# Access Compliance Report

## Public Rights-of-Way

### (Curb Ramps)

Intersection ID: 14965	Main Street: DUNN_AV	Cross Street: MONROE_RD	Location: SW
ADA ID: 866BD9690C1B	Ramp Type: PerpDiag	Initial Pass/Fail: Fail	Overall Compliance: No
		Severity Score: 35

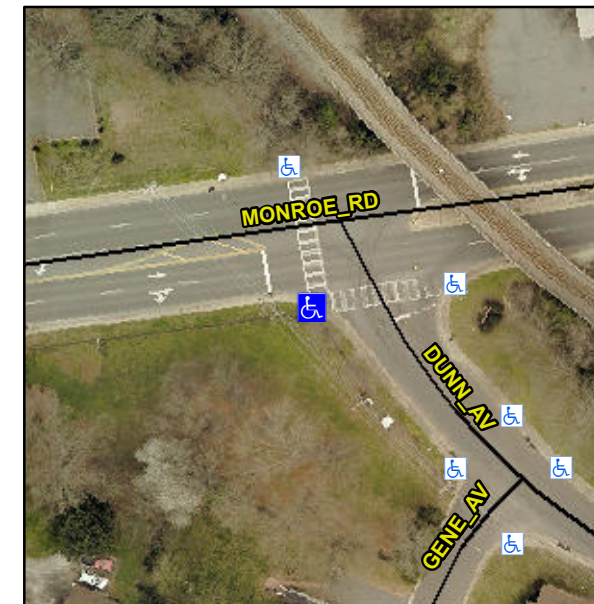
**Not Found, R304.5.1, R304.2.2**

Compliance	Description	Data	Compliance	Description	Data
N/A	Ramp Length (in)	67.0	No	Ramp Slope (%)	15.0
No	Ramp Width (in)	40.0	Yes	Ramp XSlope (%)	3.1
N/A	Flare Type LT	N/A	N/A	Flare Type RT	N/A
N/A	Flare Slope LT (%)	N/A	N/A	Flare Slope RT (%)	N/A
N/A	Flare Traversable LT?	N/A	N/A	Flare Traversable RT?	N/A
N/A	Landing Length (in)	N/A	N/A	DWS Provided?	N/A
N/A	Landing Width (in)	N/A	N/A	DWS Contrast?	N/A
N/A	Landing Slope (%)	N/A	N/A	DWS Length (in)	N/A
N/A	Landing X Slope (%)	N/A	N/A	DWS Full Width?	N/A
N/A	Landing Curb? (Y/N)	N/A	N/A	DWS Offset (in)	N/A
N/A	Shared Landing?	N/A			
N/A	Gutter Ponding?	N/A	N/A	Gutter Slope (%)	N/A
N/A	Gutter Lip Ht (in)	1.0	N/A	Gutter X Slope (%)	N/A
N/A	Painted X Walk1?	Yes	N/A	Painted X Walk2?	Yes
	X Walk 1 Direction	To E		X Walk 2 Direction	To N
N/A	X Walk 1 Width (in)	112.0	N/A	X Walk 2 Width (in)	109.0
	X Walk 1 Slope (%)	6.5		X Walk 2 Slope (%)	3.3
	X Walk 1 X Slope (%)	2.8		X Walk 2 X Slope (%)	4.7

**Remove & Replace Curb Ramp With Two New Directional Ramps or Equivalent.**
